Access Compliance Report

Public Rights-of-Way

Intersection ID: 48951	Main Street: GATESMILLS_AV	Cross Street: JOSHUA_CAIN_RD	Location: NW
ADA ID: 05766ED8A846	Ramp Type: Perp	Initial Pass/Fail: Fail	Overall Compliance: No
			Severity Score: 21.25

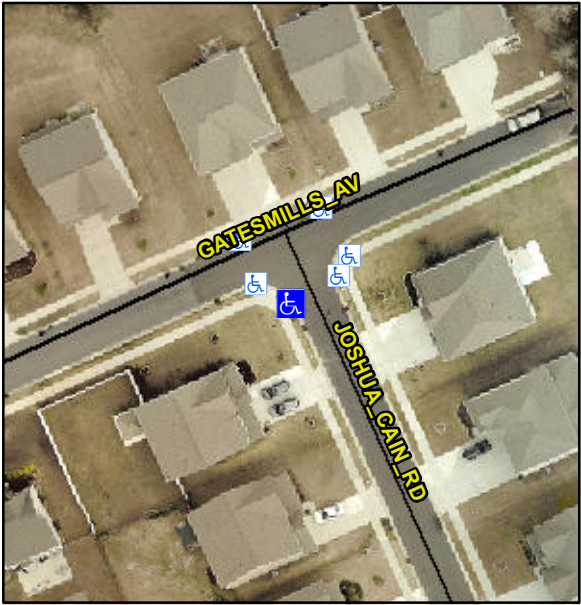
Codes/Mitigation Info/Possible Solution			Field Measurements/Component Compliance		
	Possible Solutions:		Compliance	Description	Data
	Remove & Replace Entire Ramp.		No	Ramp Length (in)	47.5
			No	Ramp Width (in)	47.5
			N/A	Flare Type LT	N/A
			N/A	Flare Slope LT (%)	N/A
			N/A	Flare Traversable LT?	N/A
			N/A	Landing Length (in)	N/A
			N/A	Landing Width (in)	N/A
			N/A	Landing Slope (%)	N/A
			N/A	Landing X Slope (%)	N/A
<p>Surveyor Notes:</p> <p>N/A</p> <p>PROW/ADA:</p> <p>Not Found, R304.5.1, R304.2.2</p>			N/A	Flare Type RT	N/A
			N/A	Flare Slope RT (%)	N/A
			N/A	Flare Traversable RT?	N/A
			N/A	DWS Provided?	N/A
			N/A	DWS Contrast?	N/A
			N/A	DWS Length (in)	N/A
			N/A	DWS Full Width?	N/A
			N/A	DWS Offset (in)	N/A
			N/A	Gutter Ponding?	N/A
			N/A	Gutter Lip Ht (in)	1.0
			No	Painted X Walk1?	N/A
				X Walk 1 Direction	To E
			N/A	X Walk 1 Width (in)	N/A
				X Walk 1 Slope (%)	2.1
				X Walk 1 X Slope (%)	1.1
